TROJAN NUCLEAR PLANT

AMENDMENT TO FACILITY OPERATING LICENSE

Amendment No. 76
License No. NPF-1

ATTACHMENT TO LICENSE AMENDMENT

FIGURE 2.1-1 REACTOR CORE SAFETY LIMIT - FOUR LOOPS IN OPERATION

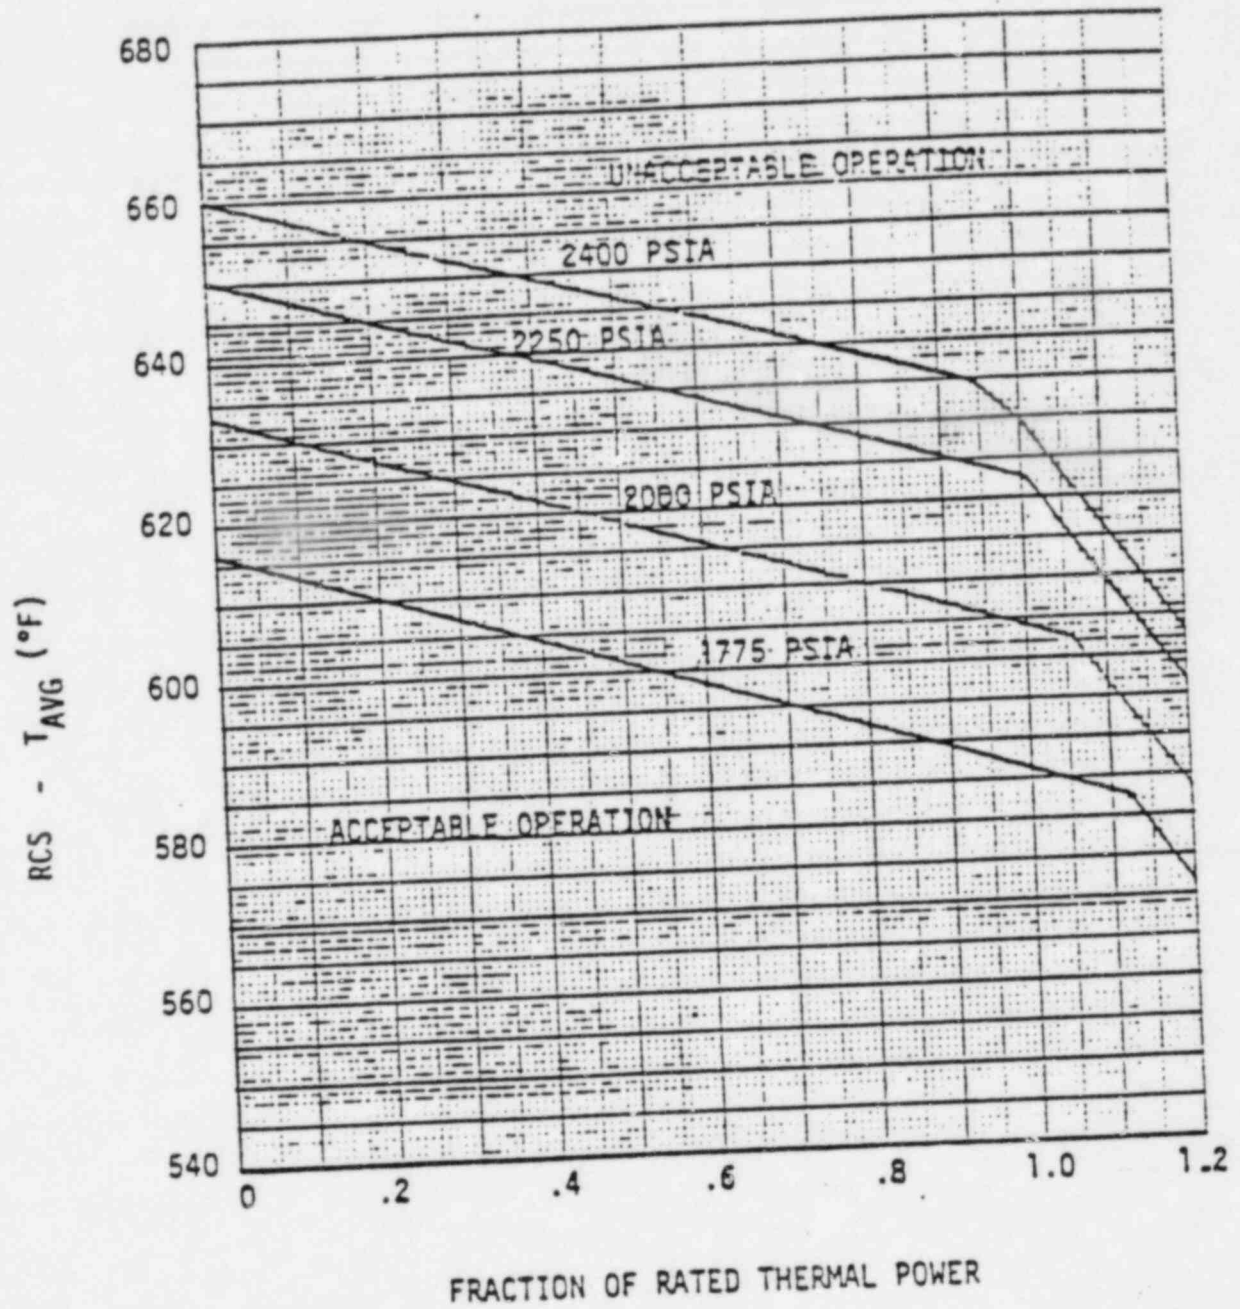
The curves are based on an enthalpy hot channel factor, $F_{\Delta H}^N$, of 1.49 and a reference cosine with a peak of 1.55 for axial power shape. An allowance is included for an increase in $F_{\Delta H}^N$ at reduced power based on the expression:

$$F_{\Delta H}^N = 1.49 [1 + 0.3 (1-P)]$$

Figure 3.2-3 Flow vs. $F_{\Delta H}^N$ Limit for 4 Loops in Operation.

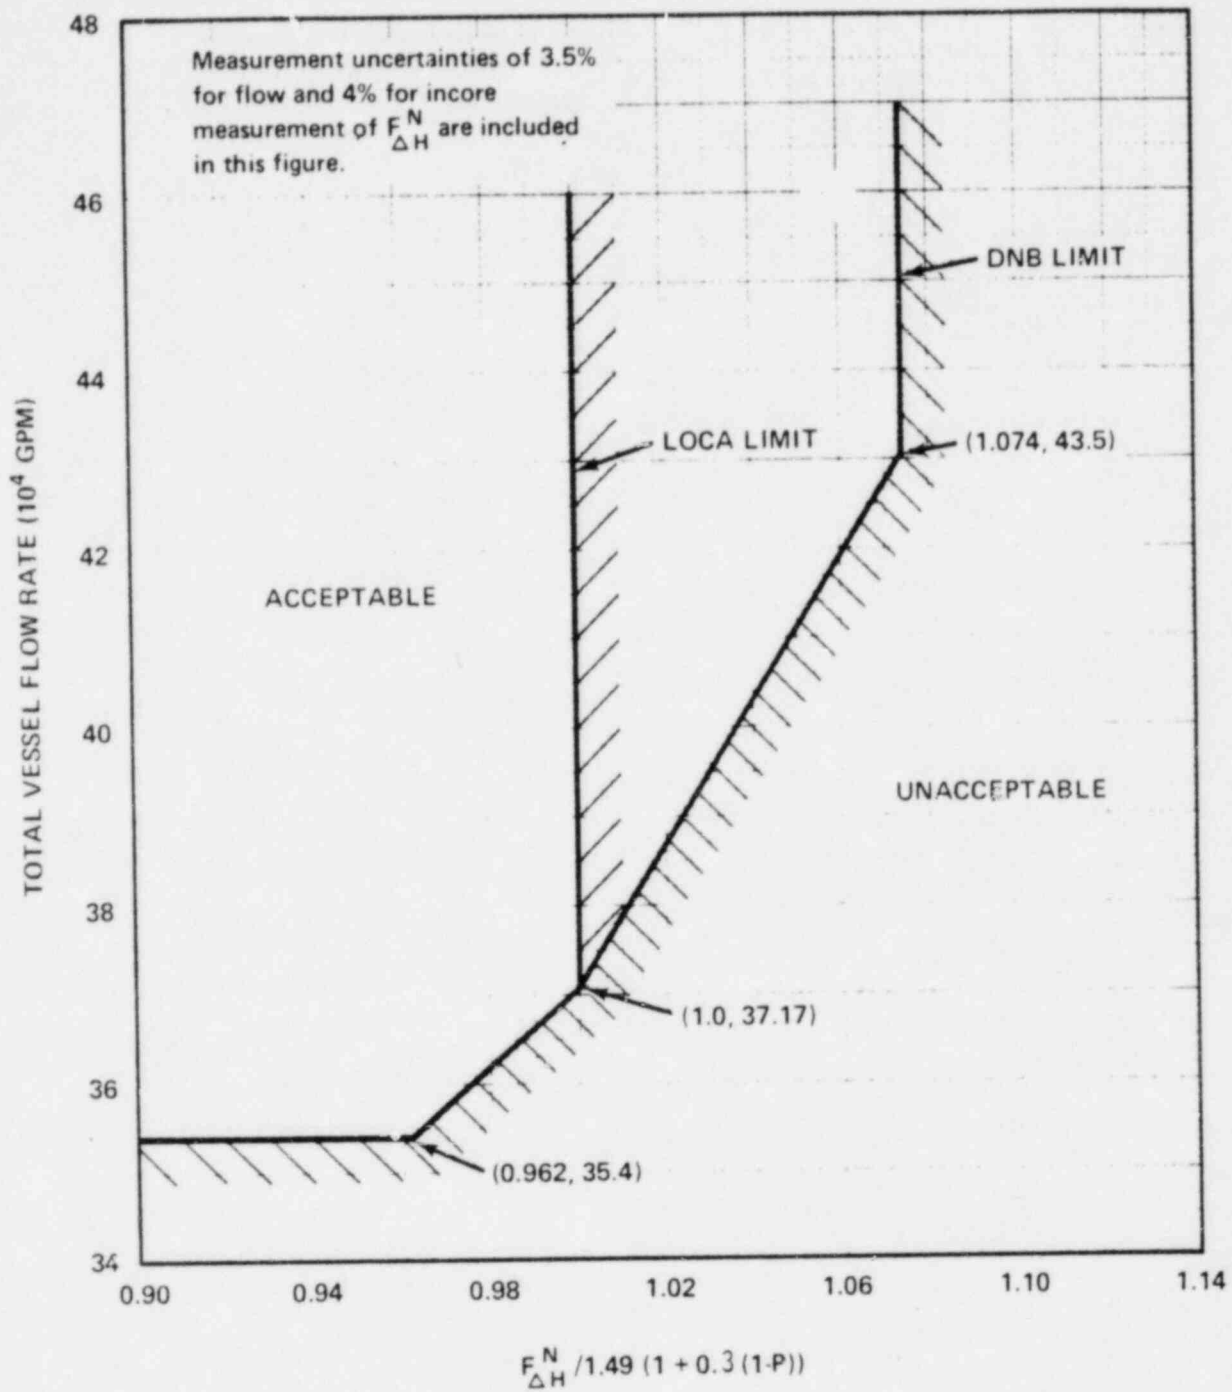
3.2.3 The combination of indicated Reactor Coolant System (RCS) total flow rate and F_R shall be maintained within the region of allowable operation (above and to the left of the line) shown on Figures 3.2-3 and 3.2-4 for 4- and 3-loop operation, respectively.

4.2.3.2 The combination of indicated RCS total flow rate and F_D shall be determined to be within the region of acceptable operation of Figure 3.2-3 or 3.2-4 (as applicable):

$F_{\Delta H}^N$ = Measured values of $F_{\Delta H}^N$ obtained by using the movable incore detectors to obtain a power distribution map. The measured values of $F_{\Delta H}^N$ shall be used to calculate F_D since Figures 3.2-3 and 3.2-4 include measurement calculational uncertainties of 3.5% for flow and 4% for incore measurement of $F_{\Delta H}^N$.
